Subject: [EXTERNAL]Draft Plan of Subdivision, ZBLA ,OPA Application (OZS-2024-0065), 10350

The Gore Rd., Brampton

RE: Official Plan Amendment, Zoning By-law Amendment & Draft Plan of Subdivision 10350 The Gore Road, Brampton

Official Plan Amendment, Draft Plan of Subdivision and Zoning By-law Amendment Applications

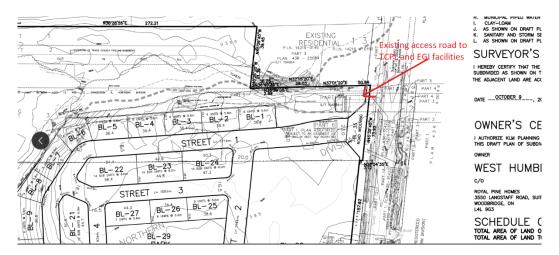
1. All aspects of Street '1' shall maintain a minimum setback of 7 metres from the edge of the TCPL Pipeline Right-of-Way.

- 2. Grading activities on the TCPL Pipeline Right-of-Way shall be kept to a minimum. Plans for grading activities within 30 metres of TCPL's pipeline must be approved by TCPL.

- 3. The Conceptual Master Plan identifies the potential widening of The Gore Road, including a dedicated turning lane into the proposed development. In addition to the setback requirements identified herein, mitigations to the pipeline may be required to accommodate road widenings. TCPL is required by the CER to prepare a detailed engineering analysis of all loads expected during construction and operation of the road widening and will provide designs for appropriate mitigation. The cost of this engineering assessment, analysis and design work, the costs of any required mitigation, and any pipe modification required due to the development, if incurred will be 100% the responsibility of the Proponent. Pipeline mitigations may take several years to execute, and the Proponents is encouraged to engage TCPL early on in their process.
